**CITY OF CROSSLAKE  
PLANNING COMMISSION/BOARD OF ADJUSTMENT**

**PUBLIC HEARING NOTICE**

**Applicant:** Daniel J McGraw

**Site Location:** 12525 Anchor Pt Rd, Crosslake, MN 56442 on Rush Lake - GD

# CERTIFICATE OF SURVEY

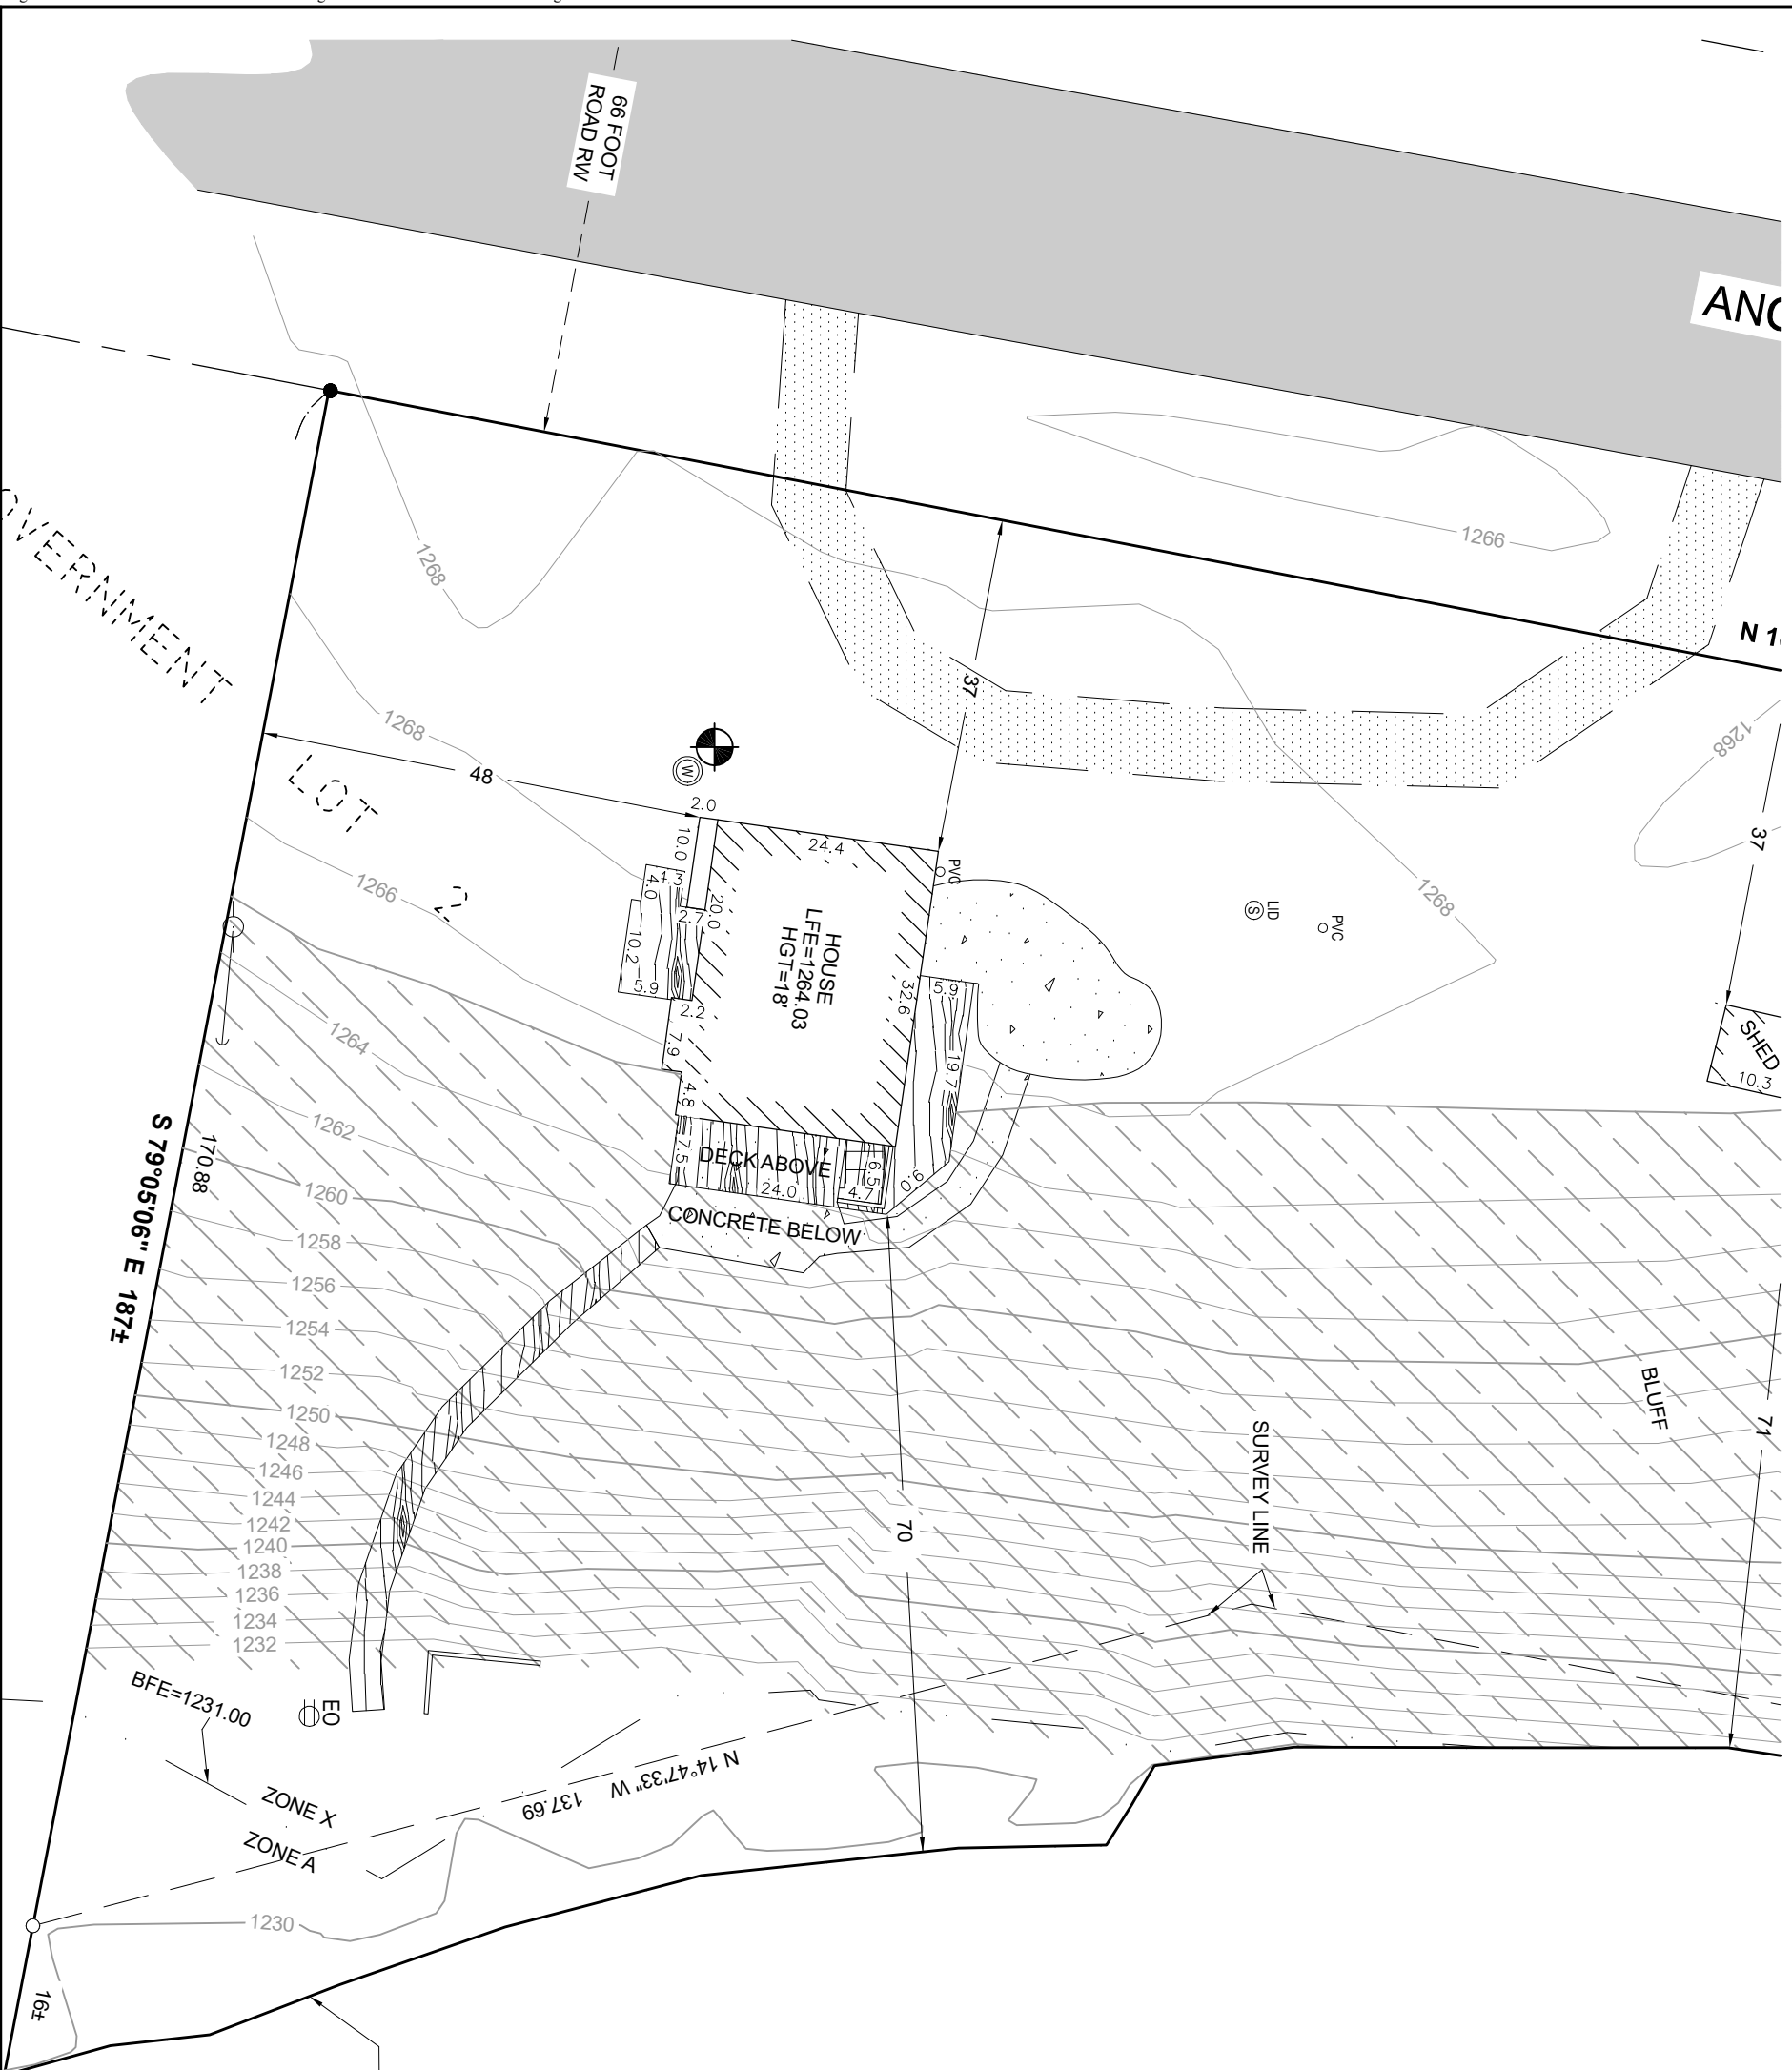
2. I see on the survey there are stairs coming off of the existing deck in the bluff. The ordinance allows a 4 foot stairway with landing that must not exceed 32 sf in area and be integral to the function of the stairway and not constitute a deck. Please put a "call out" or add a note, indicating the maximum sq foot of the landing and the maximum width of the stairway. (it appears the landing maybe 34 sf on the survey???? Can't really tell 8.5 x?)

# Crow Wing County Trench/Pressure Bed Design

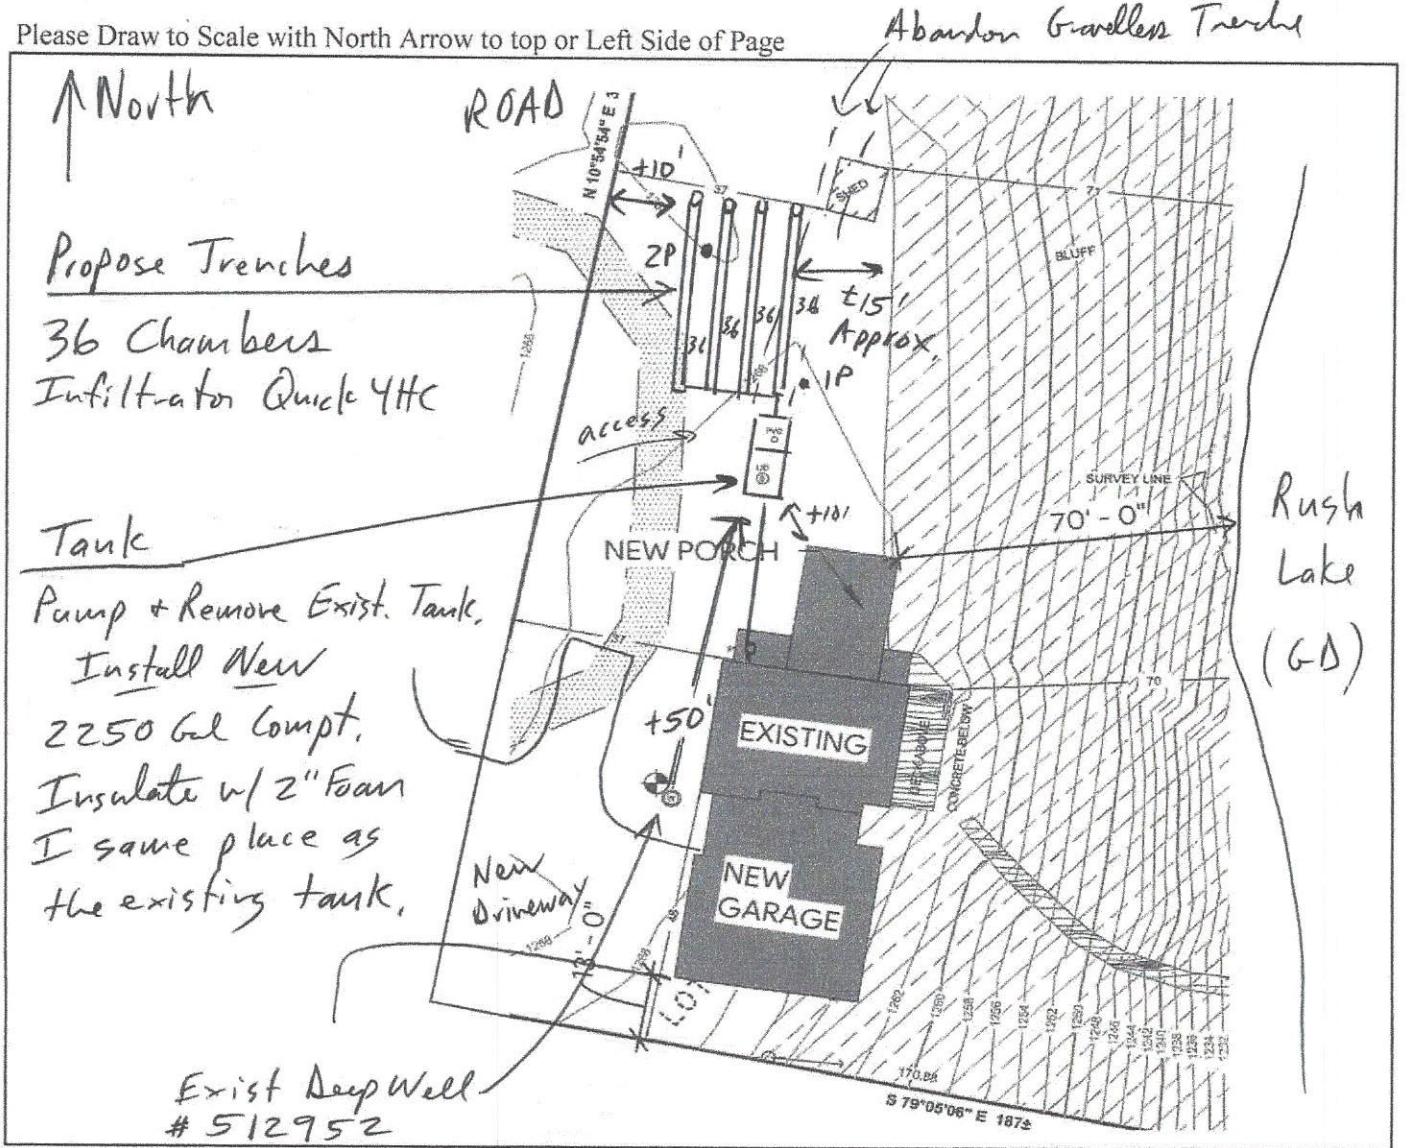
This is the only septic area on the property.  
\* Septic Will Need a Variance for the Bluff Setback = < 30'
